CITY PLAN COMMISSION STAFF REPORT

The Dotte at Metro North

CD-CPC-20214-00071
Development Plan - Residential

Plan Conditions, Corrections, & Suggestions Report

EXISTING CONDITIONS / TREE
PRESERVATION PLAN
Development Plan for:
The Dotte at Metro North
Kansas City, Clay County, Missouri

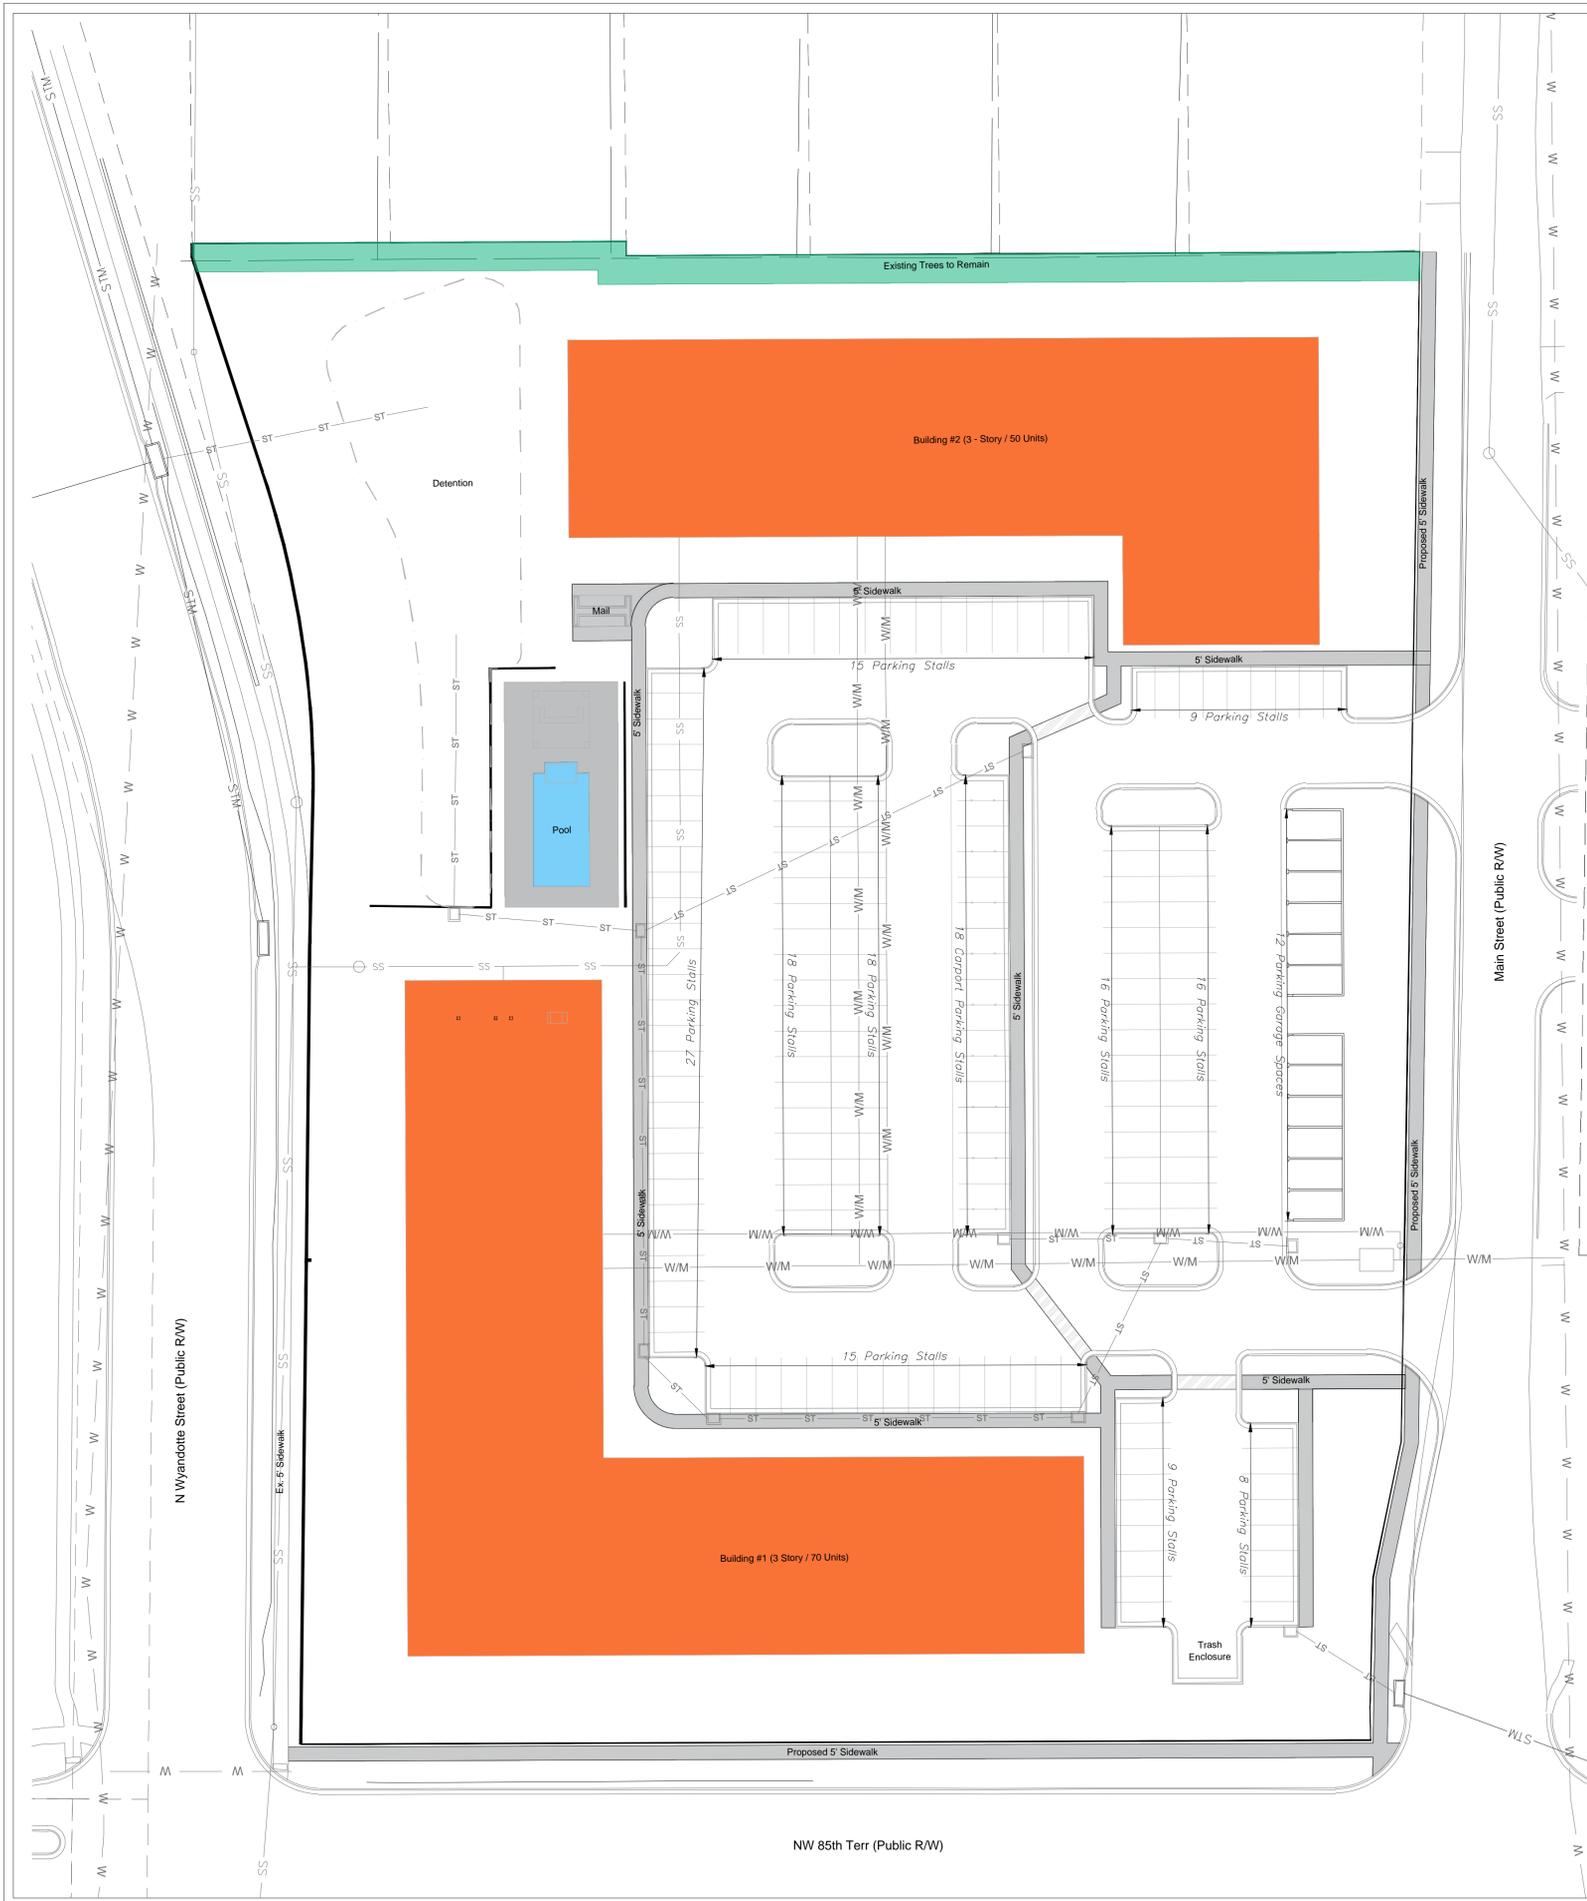
5. Add a note to the drawing of existing trees to be removed. UPDATE 7/1/24: The label on C.002 should be changed from "Ex. Tree Mass" to "Ex. Tree Mass to be Removed" (6/28/2024)
6. UPDATE 7/1/24: 12 trees are required for mitigation based on 2" caliper trees, not 8. Revise tree mitigation plan (C.002) and landscape plan (L.100). Additionally, landscape plan indicates 3" trees and all should be 2". (6/28/2024)

OVERALL SITE PLAN
Development Plan for:
The Dotte at Metro North
Kansas City, Clay County, Missouri

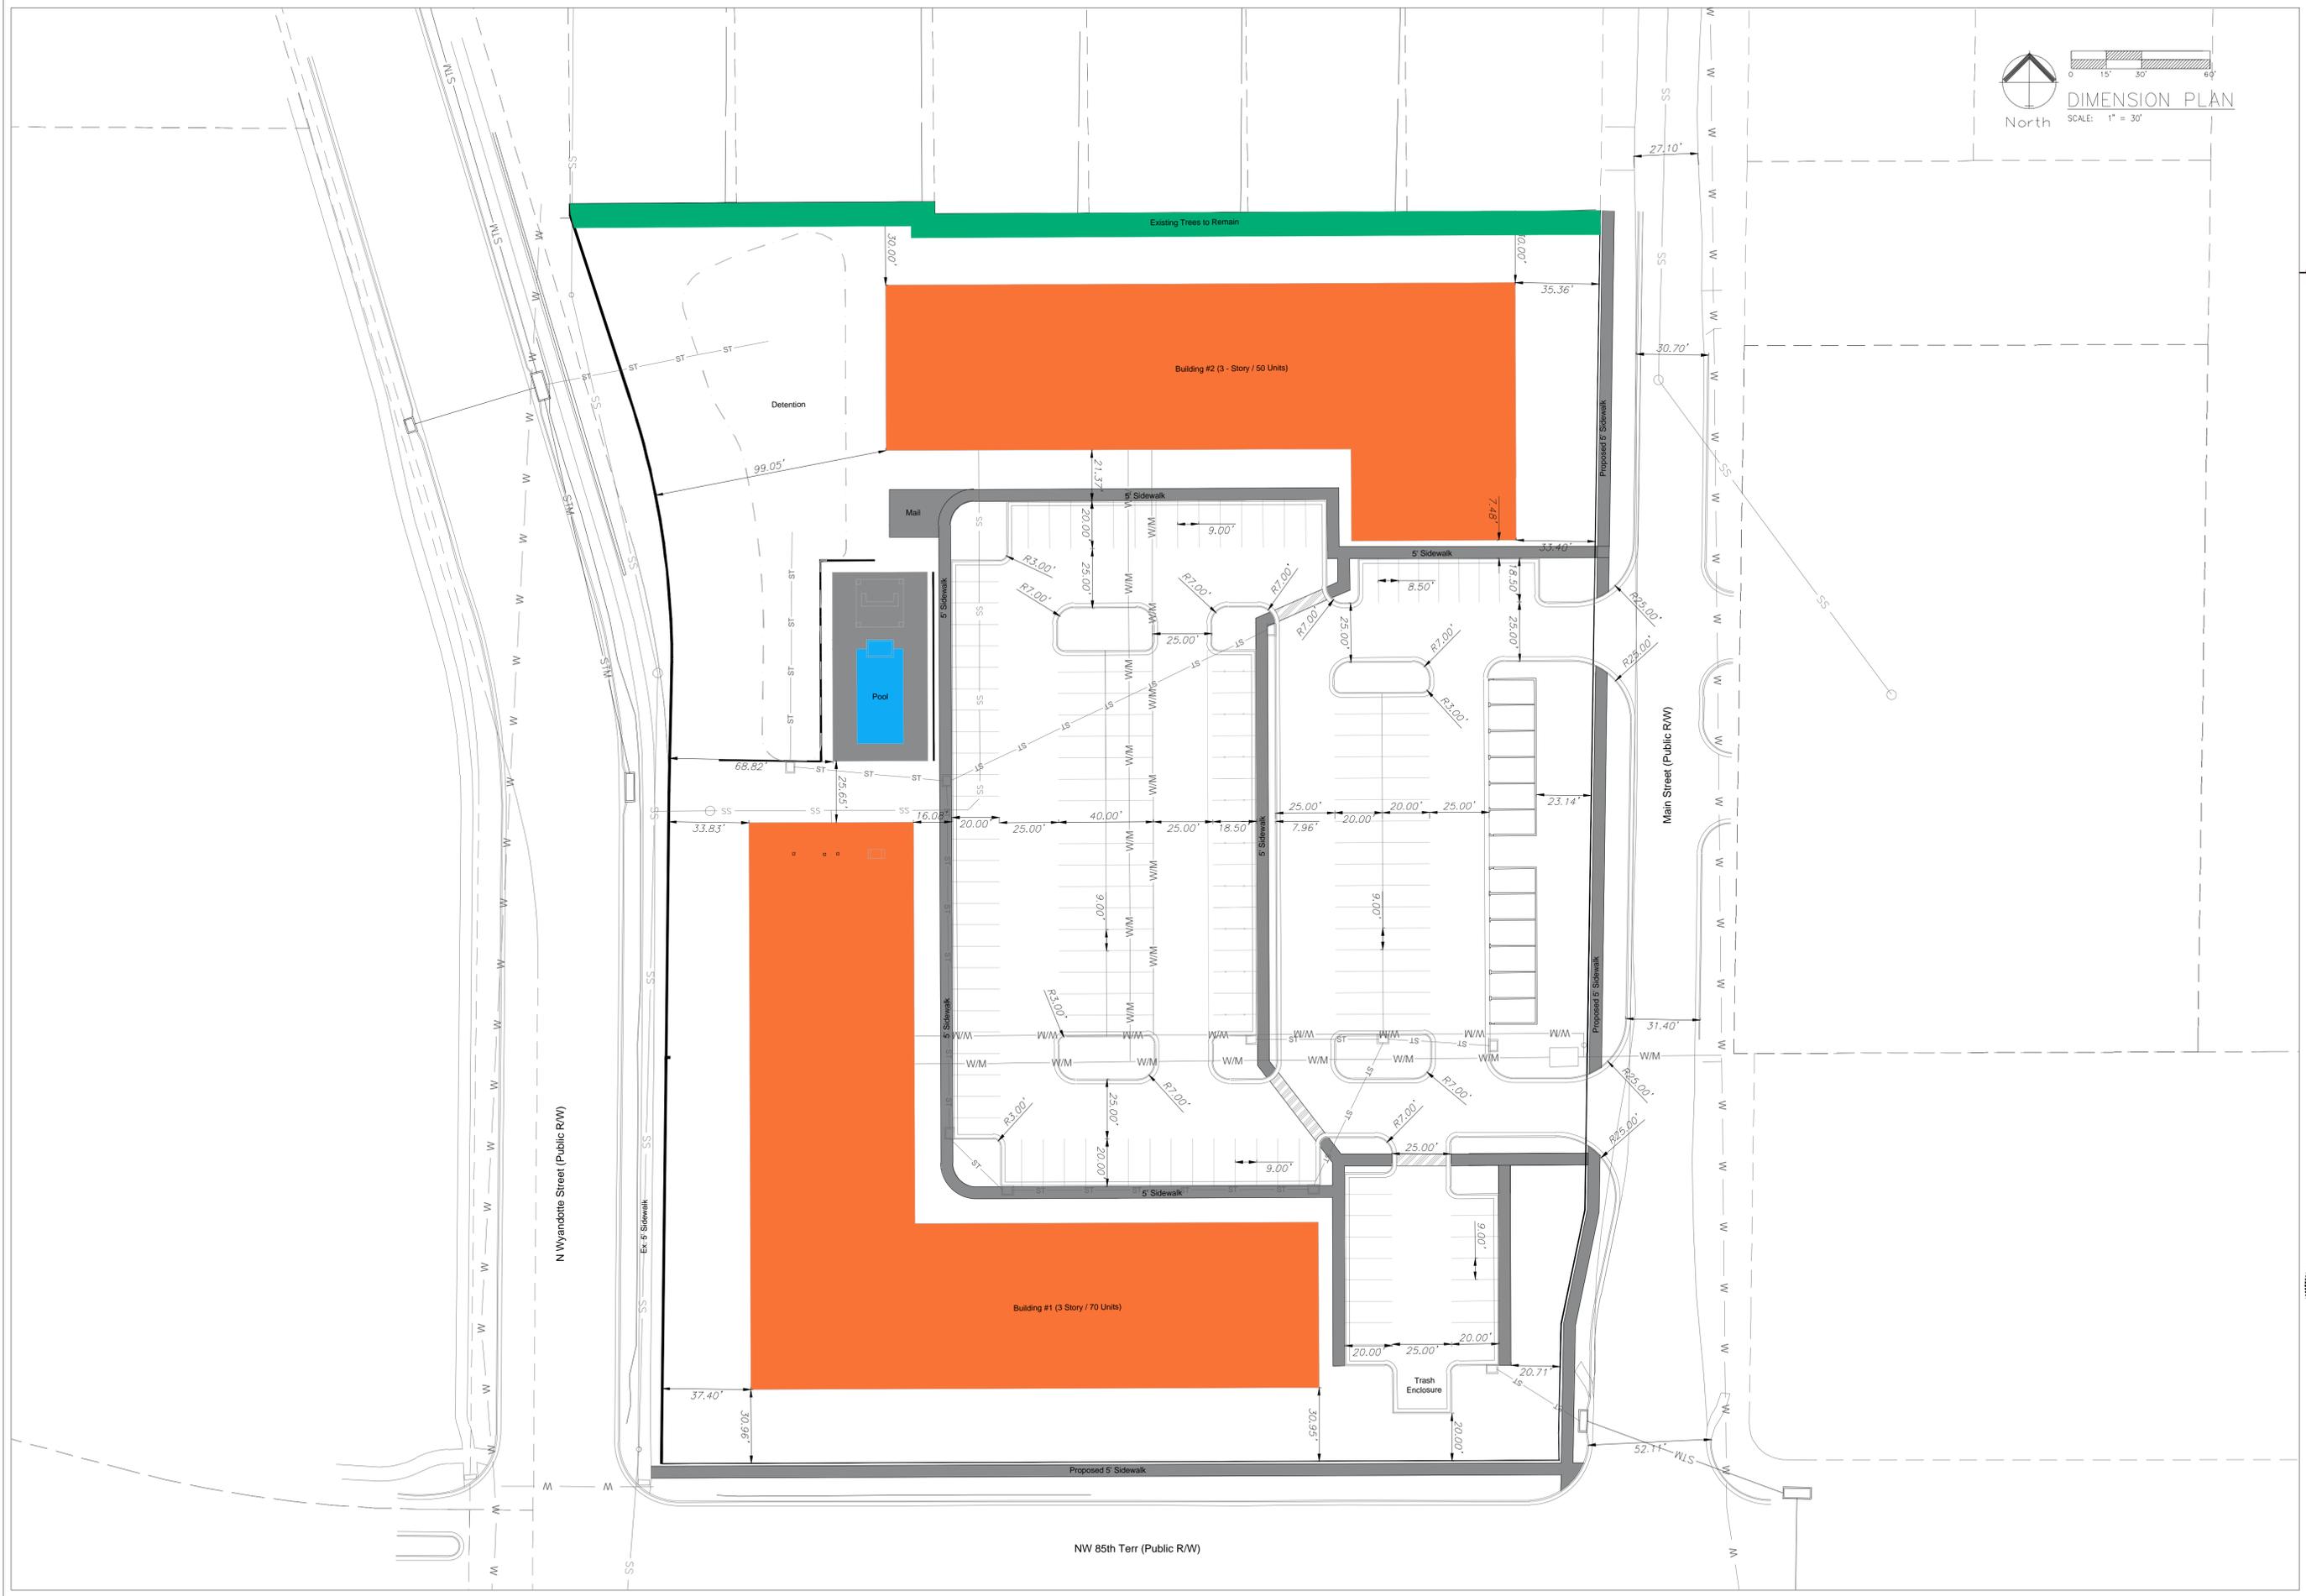
The site layout is slightly excessive in impervious area where the parking is located. The proposed number of parking spaces exceeds what's required by 60 spaces. Staff requested the applicant remove

the 17 spaces at the southeast corner of the site to improve the aesthetic and view of the corner, but they chose not to revise per staff's request.
